Advisian Submission Regarding AEMO's proposed rule changes for the Generator technical performance standards

**Submission to AEMC
Advisian Submission Regarding
AEMO's proposed rule changes for
the Generator technical
performance standards**

Project No: - – Advisian Submission Regarding

AEMO's proposed rule changes for the Generator technical performance standards:

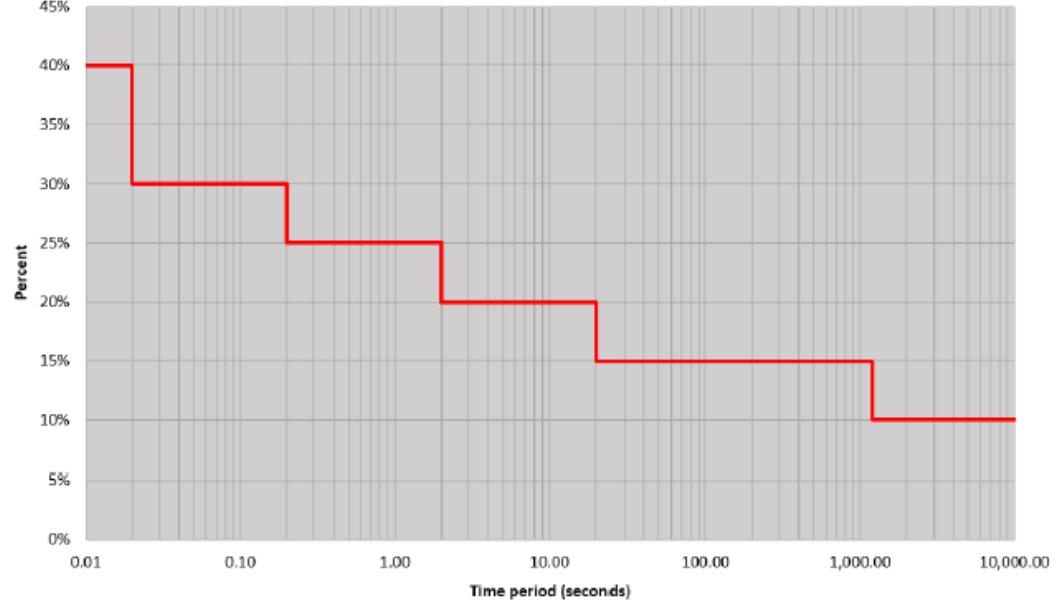
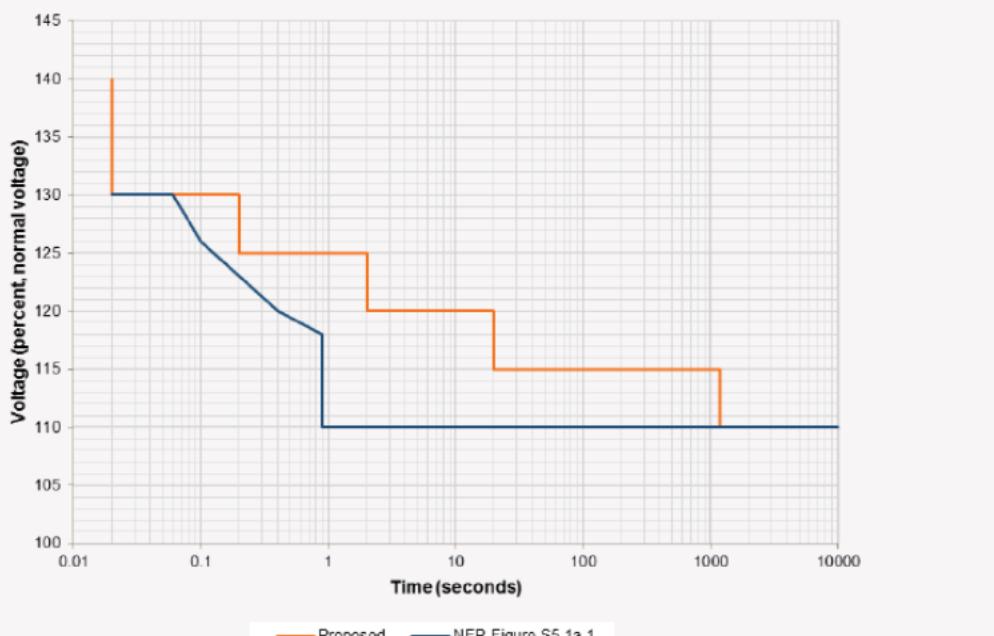
AEMO's proposed Rule Changes	Comments by Advisian
<p>S5.1a.4 Power frequency voltage [The only changes proposed by AEMO are to replace Figure S5.1a.1. with the following]</p> <p style="text-align: center;">Percentage overvoltage</p>  <p>Figure 5 Proposed system standard for power frequency over voltage</p> 	<p>S5.1a.4 Power Frequency voltage</p> <p>These requirements appear to be very onerous and many generators currently connected to the system will not be able to meet these over voltage levels without sustaining damage or significant loss of life for insulation componentry.</p> <p>AEMO have not provided any justification above the 115% level (which is currently the highest power frequency overvoltage allowed) and do not appear to have investigated what the possible impact of this change is on new and existing generation plant.</p> <p>Whilst new generation plant can be built to comply, this would result in an over investment in electrical insulation and voltage rating of equipment.</p> <p>Existing plant, in particular synchronous and asynchronous generators, transformers, capacitor banks, cables, power electronics and other electrical components would be at risk of significant damage if exposed to high over voltages for the time periods being proposed.</p> <p>S5.1a.4 Recommendation</p> <p>Advisian recommend this proposed change be rejected for the reasons set out above.</p>
